Exhibit C – Plans

DSA 140 and DSA Addendum 01.....73-220

CORONA-NORCO USD TRANSPORTATION OFFICE AT ORANGE GROVE HIGH SCHOOL

100% CONSTRUCTION DOCUMENTS

GRADING PLAN
C2.1

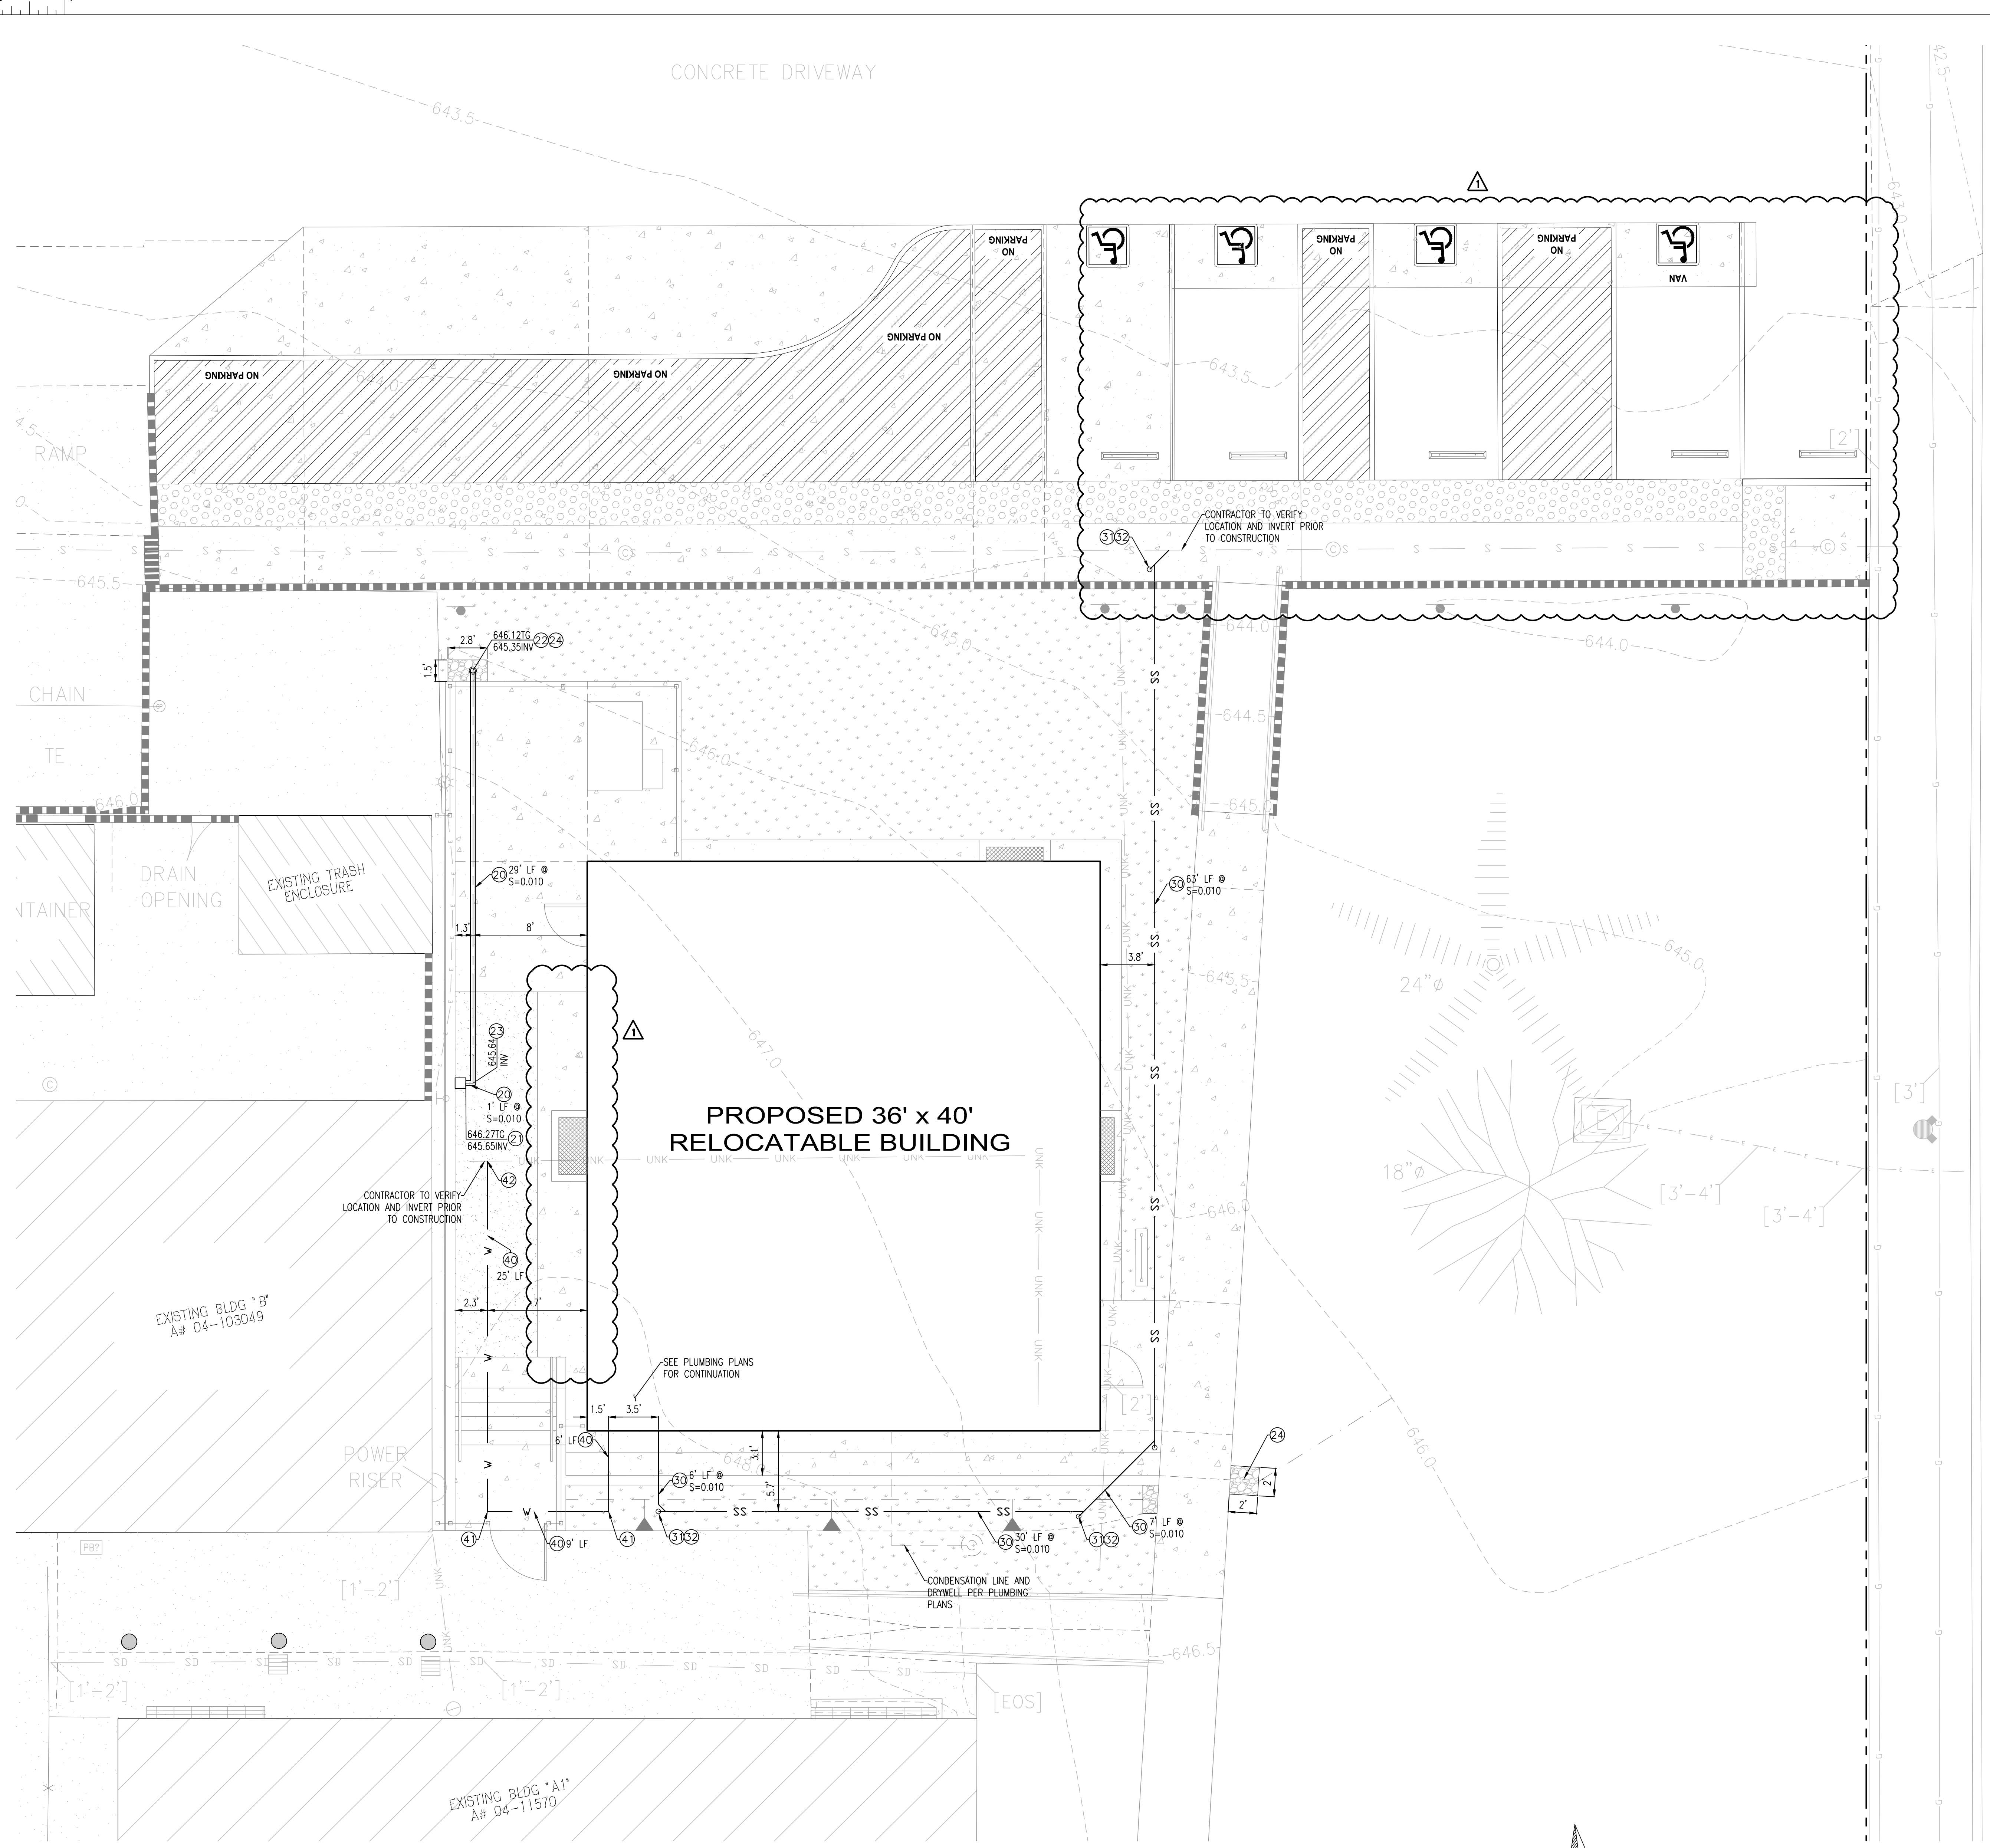
- Item No. 01.17:** Sheet C2.1: Revised “Quantities” for “Construction Items” #1, #2 & #14.
- Item No. 01.18:** Sheet C2.1: Revised “Grading Plan”, the following items where revised:

- iv. Concrete along westerly face of proposed modular building widened.
- Item No. 01.19:** Sheet C2.2: Revised “Utility Plan”, construction limits reduced for proposed parking lot and fixed parking stall designation, only 1 space is designated as “VAN”.

SECTION A-A
 HORIZ SCALE: 1"=5'
 VERT SCALE: 1"=1'

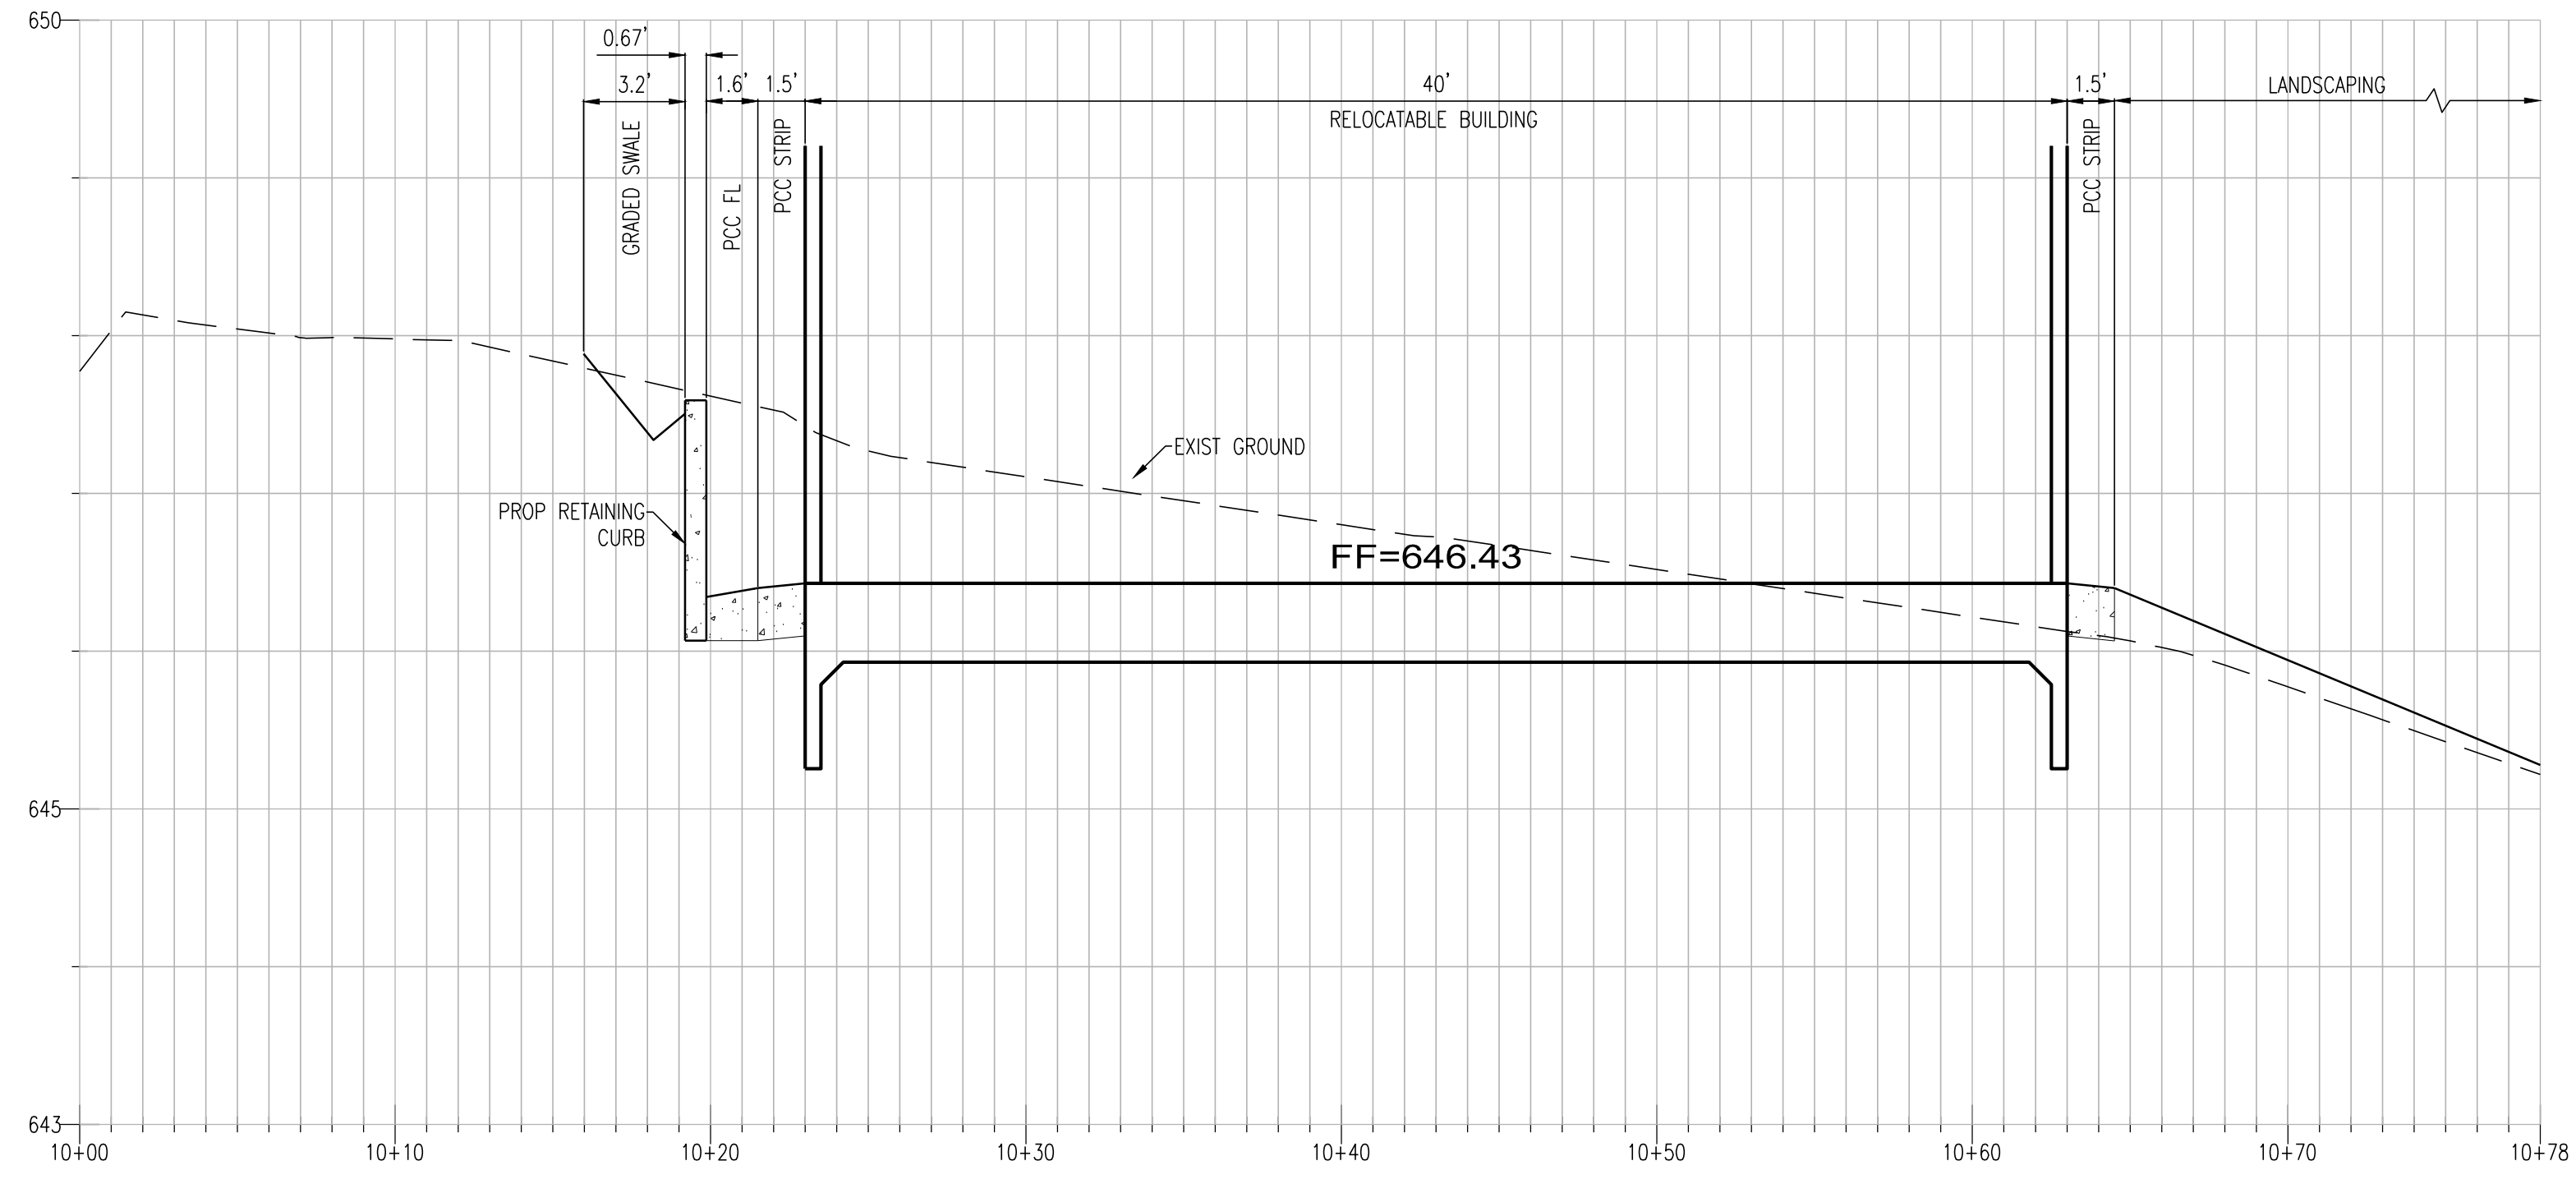
- Item No. 01.20:** Sheet C3.1: Revised “Section A-A”, updated to show widening of concrete adjacent to proposed modular building.
- Item No. 01.21:** Sheet C4.1: Revised “Erosion Control Plan”, construction limits reduced for proposed parking lot and fixed parking stall designation, only 1 space is designated as “VAN”.

3 PROPOSED FLOOR PLAN

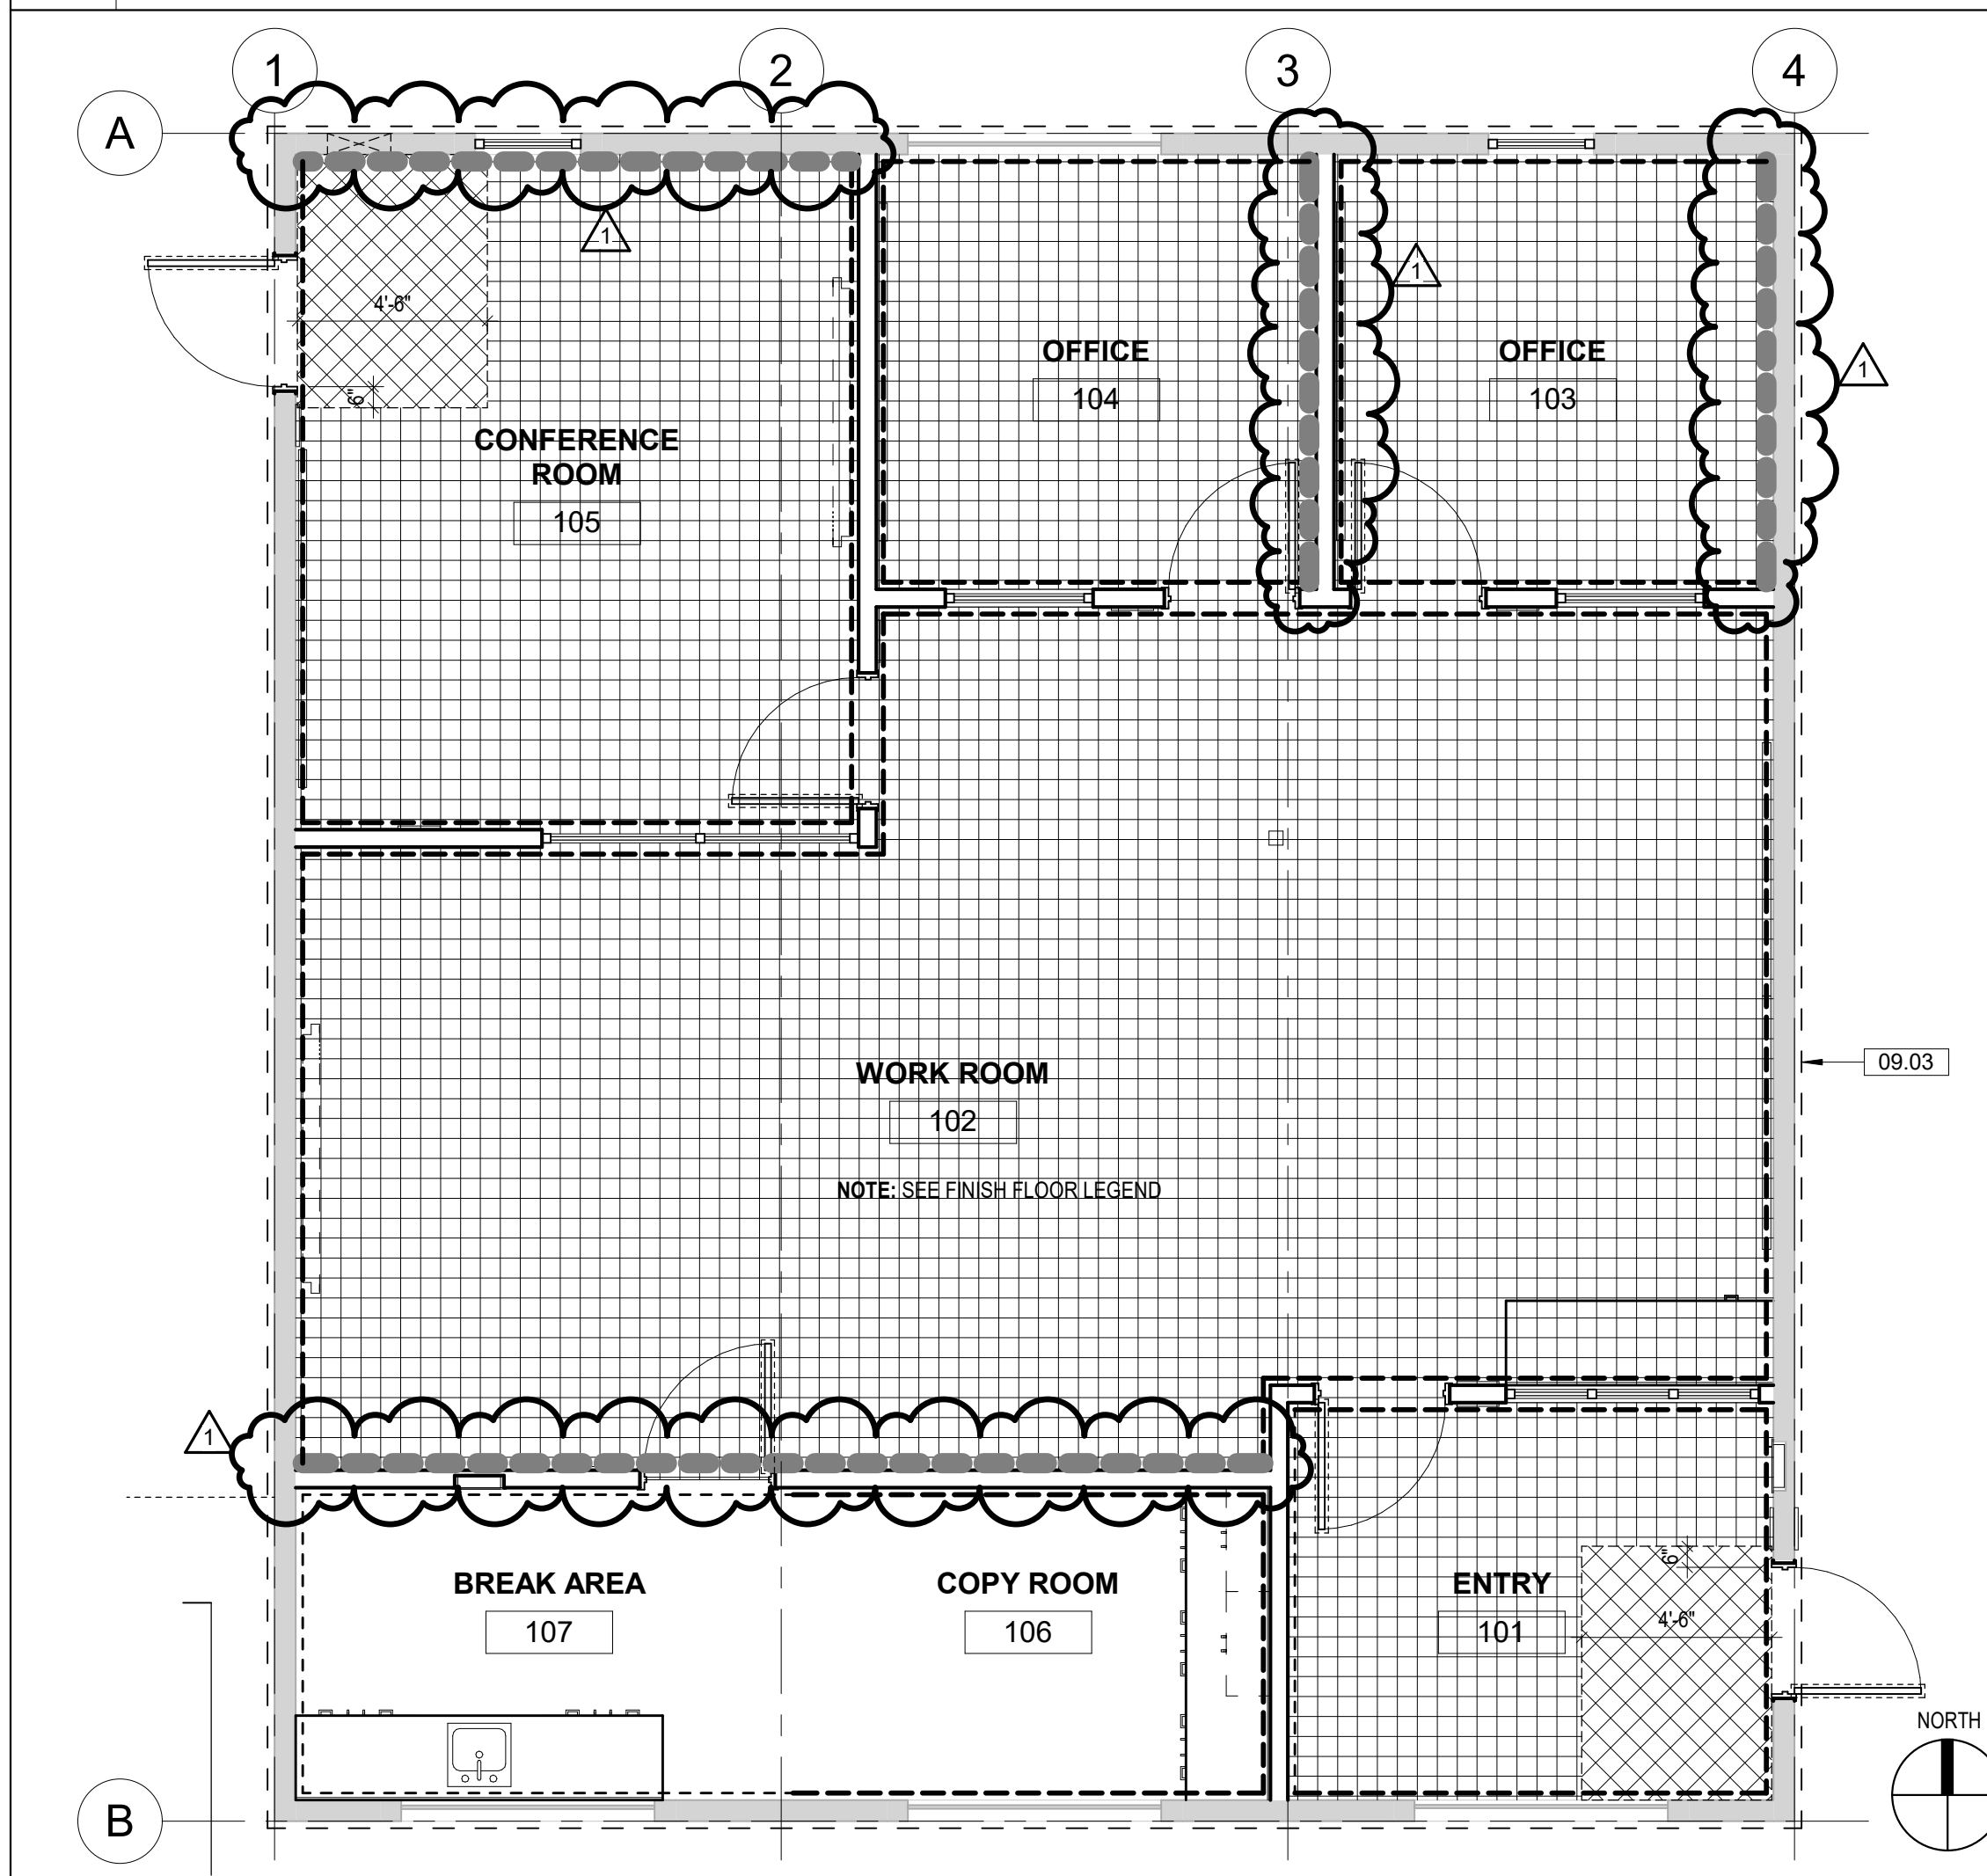
- v. “TS-2” added and reads: Koroseal / Chatfield Clarke, Interloom, Haze NM21-05
- Item No. 01.25:** Sheet A9.01: Revised Detail 3 “Proposed Floor Plan”, delineated “TS-2” wall finish areas for the Work Room, Conference Room and Office spaces.
